**CONTRACTOR'S INQUIRY RESPONSES****HESPERIAN BOULEVARD****CORRIDOR IMPROVEMENT PROJECT**

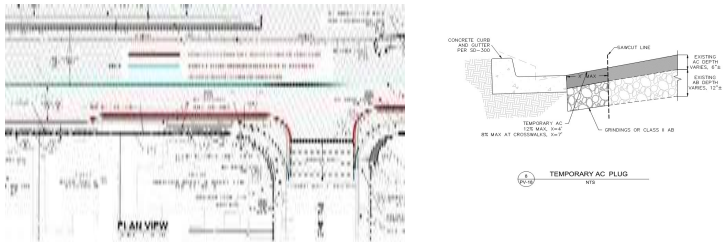
24	<p>Section 39-2.09B does not have any gyration designation for Level 1 or Level 2 HMA-LV. Please clarify how many gyration for each Level of HMA-LV</p>	<p>See Addendum 3  Clarifying information has been added to section 39-2.01B(2).</p>
25	<p>There is no specification or model numbers listed for the tables. Will this be coming out or is there a City standard?</p>	<p>Tables have been removed per Addendum No. 2</p>
26	<p>Can you please confirm which section of the median island between Sta. 152+00 to 155+92 will remain and which section will be removed. Sheet 52 &amp; 53 of the demolition plans indicate [RD] &amp; [RE] for the same median? See attached plan cut-out.  [RD] Remove and Dispose of Existing Facility  [RE] Existing Facility to Remain  Attachment</p>	<p>See Addendum No. 3.  Replace sheet 53 (DE-16) with sheet 53 (DE-16) Revision 1</p>
27	<p>Can you please verify if sheet note [19] @ Sta. 155+00 on the NB direction of Hesperian Blvd is correct. The hatching indicates AC Removal Limits [9] as noted at Sta. 152+95 Please see attached Sheet 52 &amp; 53 of the demolition plans indicating [9] &amp; [19] for the same pavement improvement? See attached plan cut-out.  Attachment</p>	<p>See Addendum No. 3.  Replace sheet 53 (DE-16) with sheet 53 (DE-16) Revision 1</p>

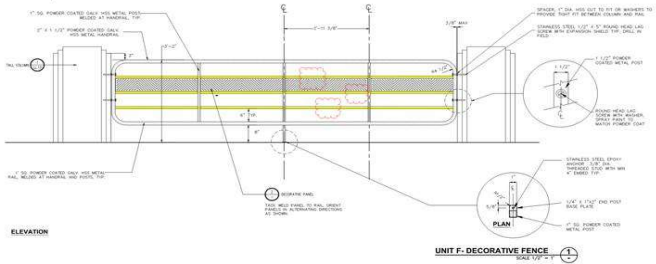
35 According to Section 39-3.04 "Cold Planing Asphalt Concrete Pavement", paragraph #3 said "Schedule cold planing activities such that the pavement is cold planed, and the area is open to traffic during the same work shift". This statement is standard clause for Caltrans for work being done on freeway. Normally, the County allow three (3) calendar days after the initial key cut or milling operation. Please clarify.

See Addendum No. 5. You are not required to place HMA during the same work shift, but you are required to open all areas to traffic with proper temporary tapers as needed. You are allowed three (3) calendar days after the initial cold planing of an area to place HMA to the final grade under section 39-3.04C(1).
